**Project: South Battery Park City Resiliency Project:  
Pier A Plaza / Battery Site Work And Near  
Surface Isolation (“NSI”) Construction Services  
Request for Proposals (“RFP”)**

**Date: February 2, 2023**

**RE: Addendum #7  
# of Pages: 85**

**ATTACHMENT #2**  
**REVISED STRUCTURAL DRAWING**  
***SS405: Site Structure Sections – Battery***

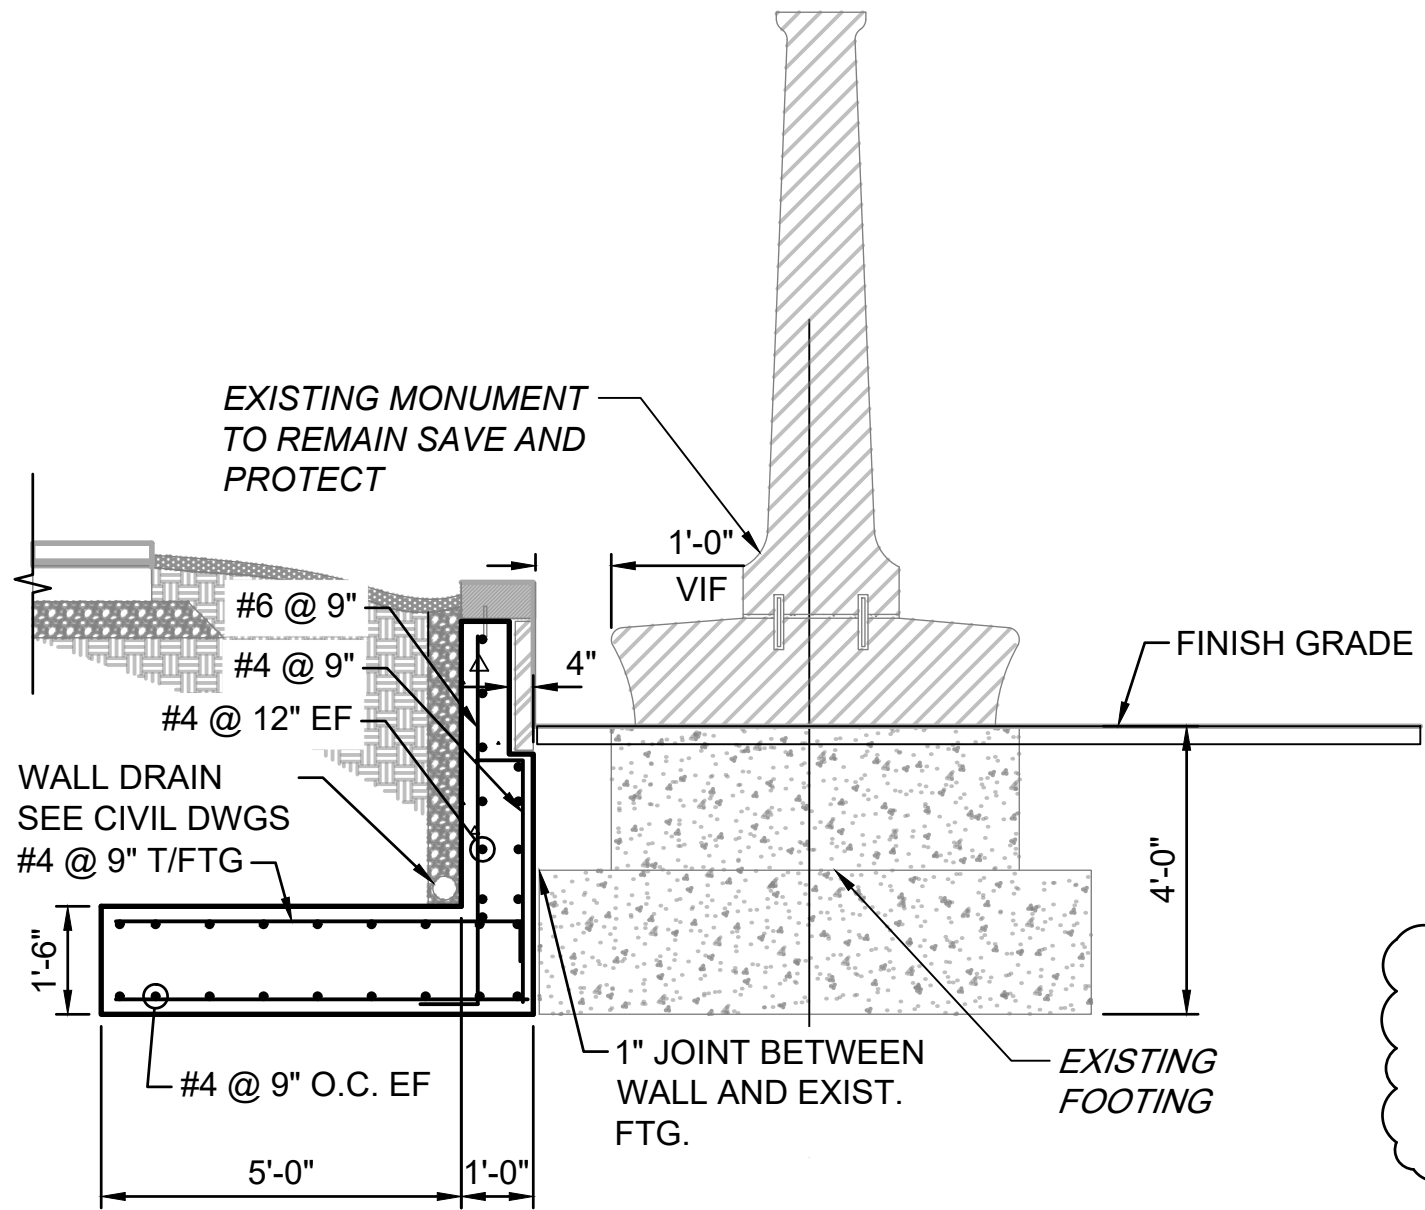
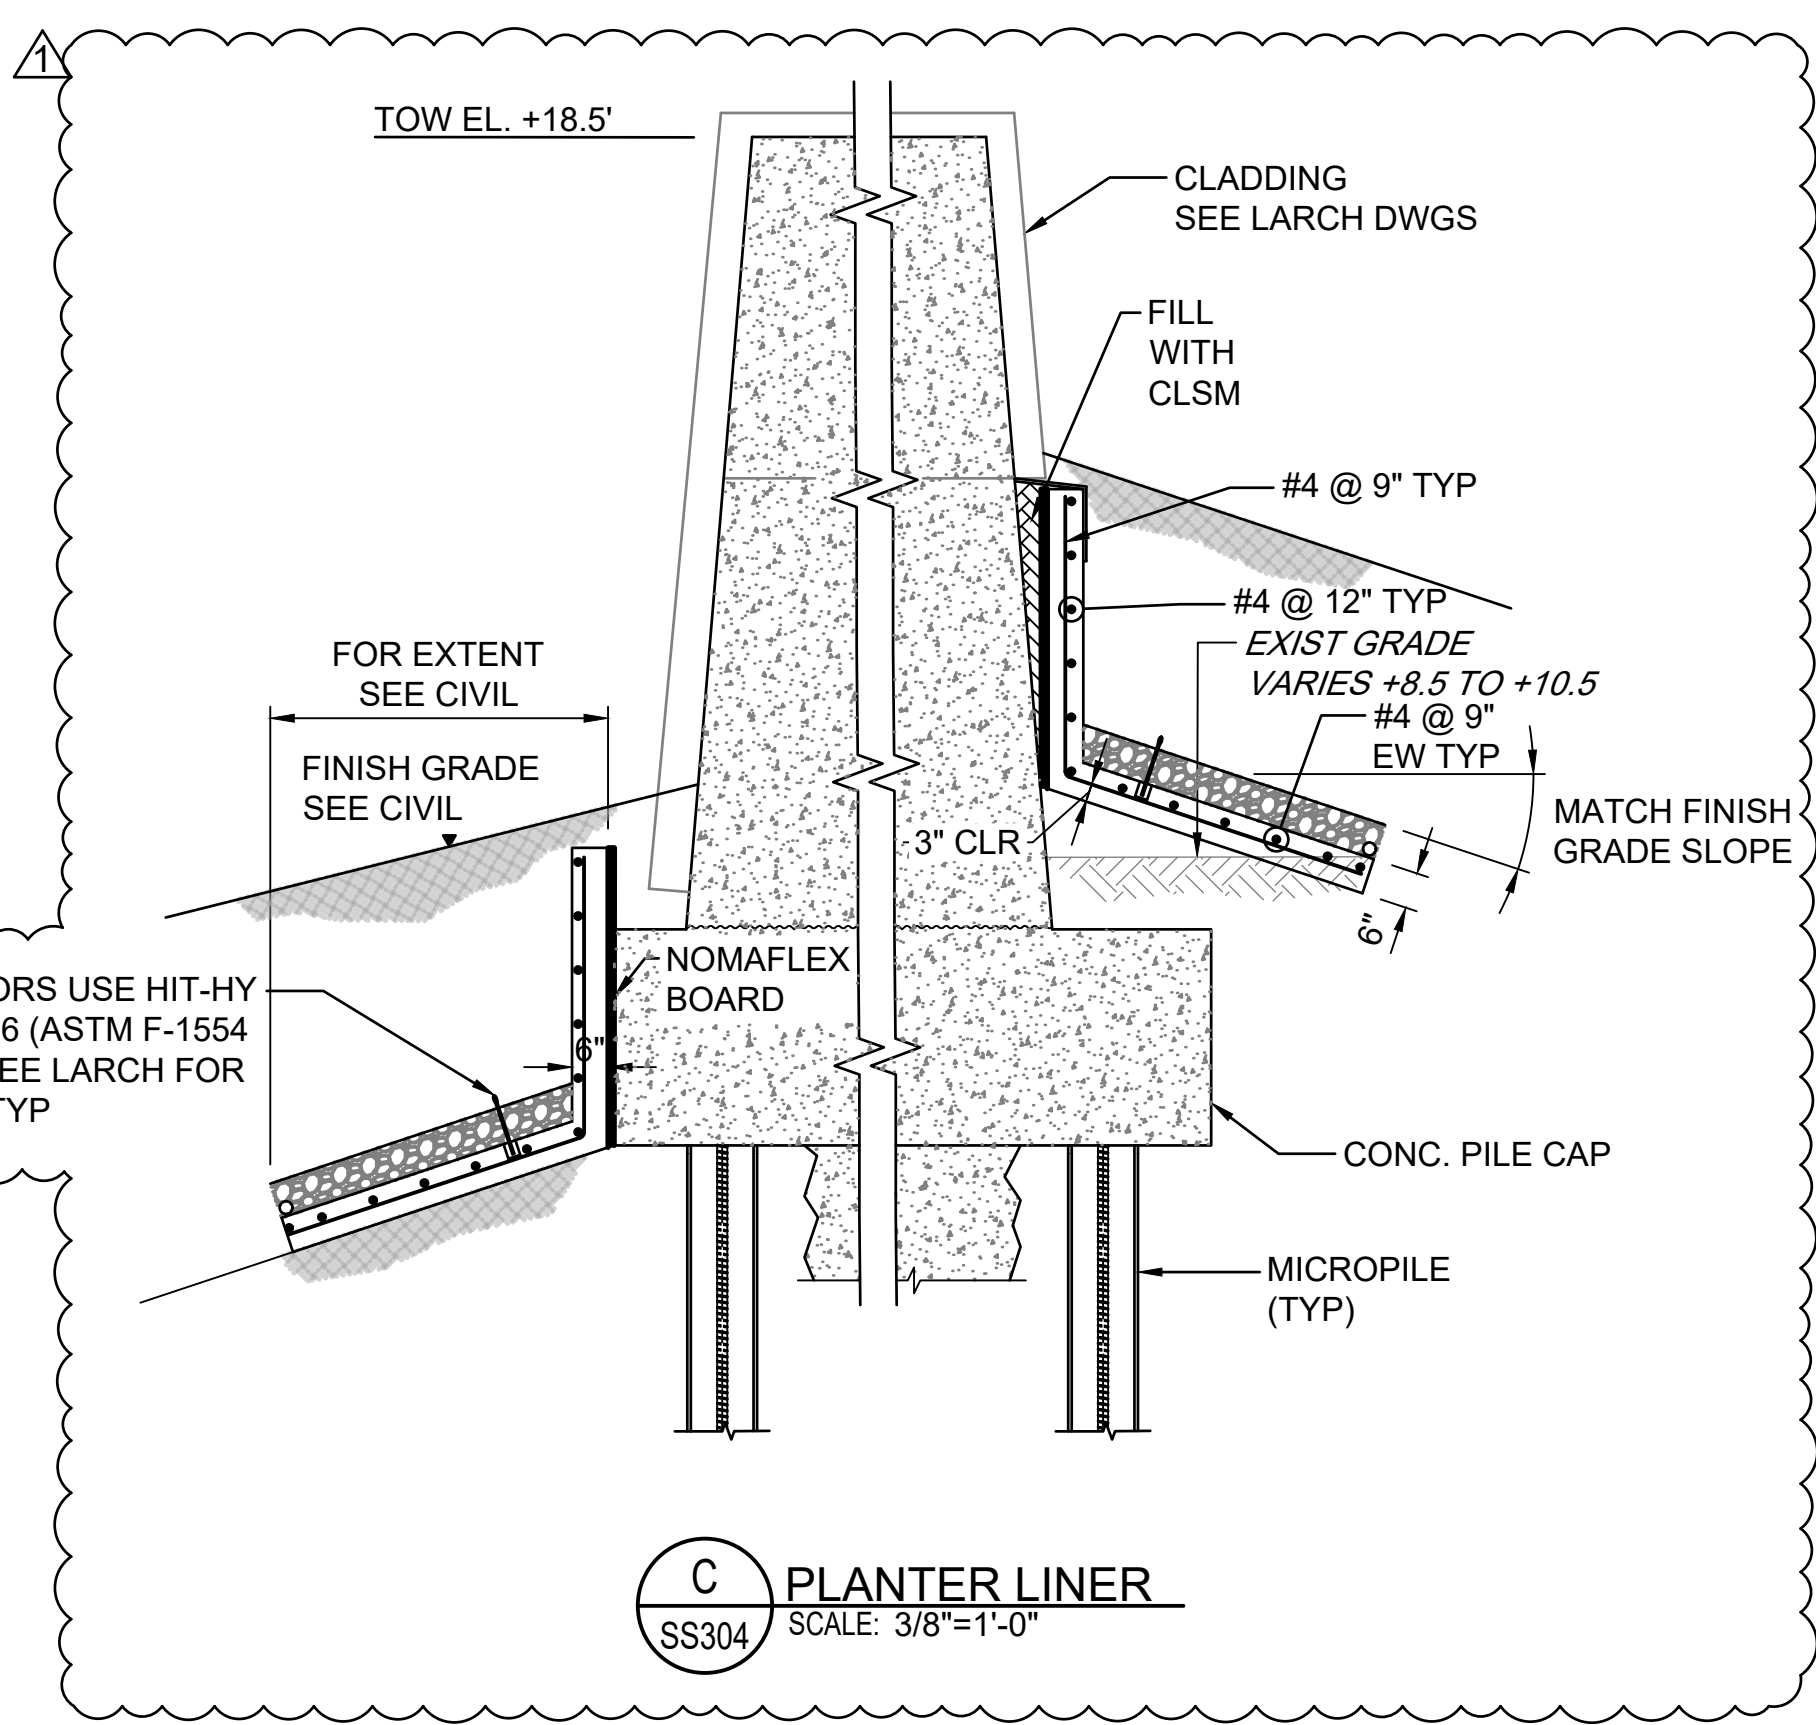
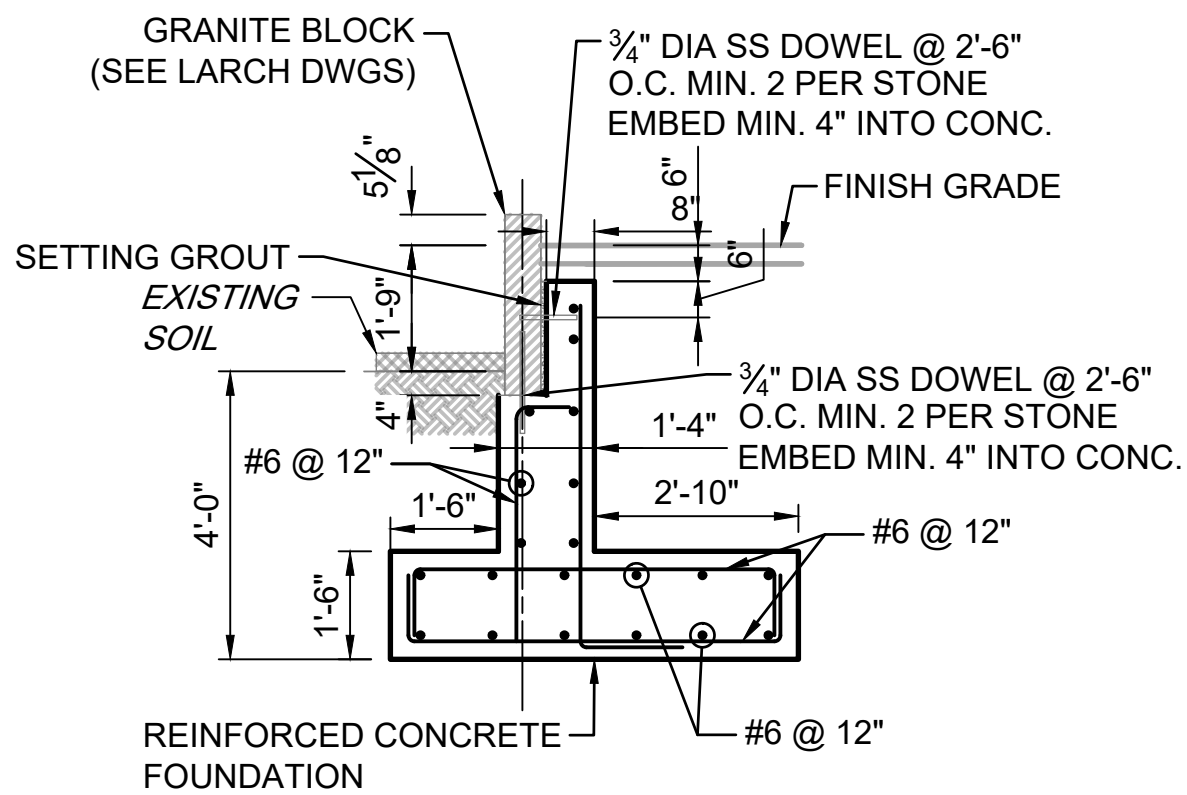
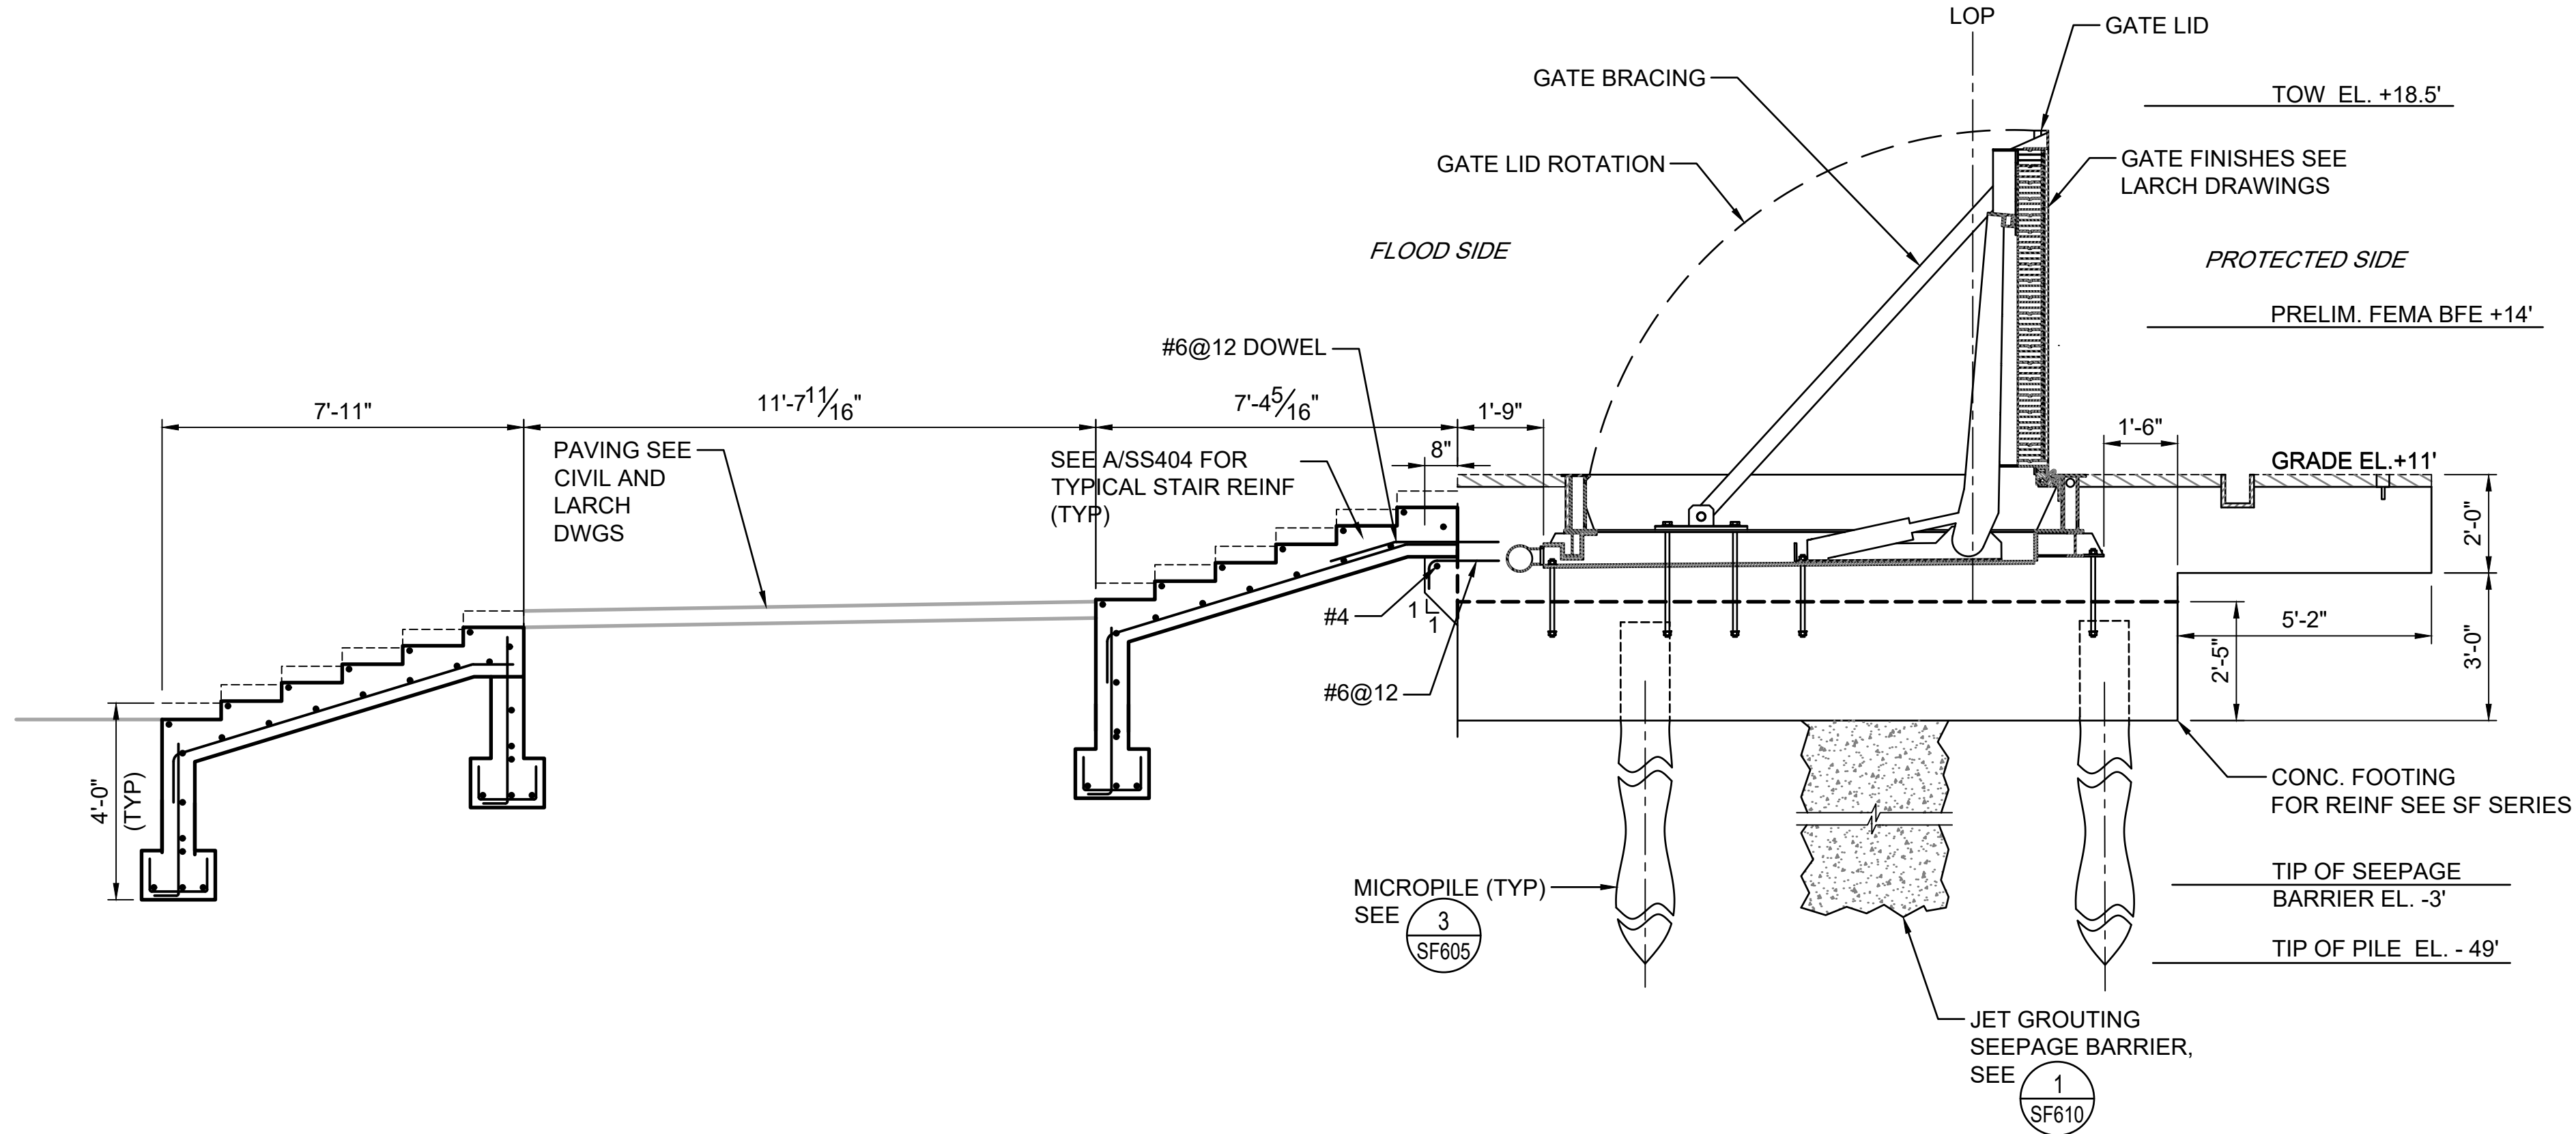
***As indicated in Section A – REVISIONS TO RFP (above), a clean PDF copy of Drawing L945 is provided as part of Attachment #1.***
- 24) Please refer the area labeled "CONC PLTR TUB TYP. SEE NOTE 3" on Drawing C-224. This points to details on drawing C-812, which indicates a concrete slab at the bottom of this planter tub. It also states to see structural drawings for details of this slab, however the structural drawings do not show this bottom slab at all. Please provide details and extents of this concrete bottom slab at the planter tub.

***A detail has been added to Structural Drawing SS405. As noted in Section A – REVISIONS TO RFP (above), a revised version of Drawing SS405 is provided as Attachment #2.***
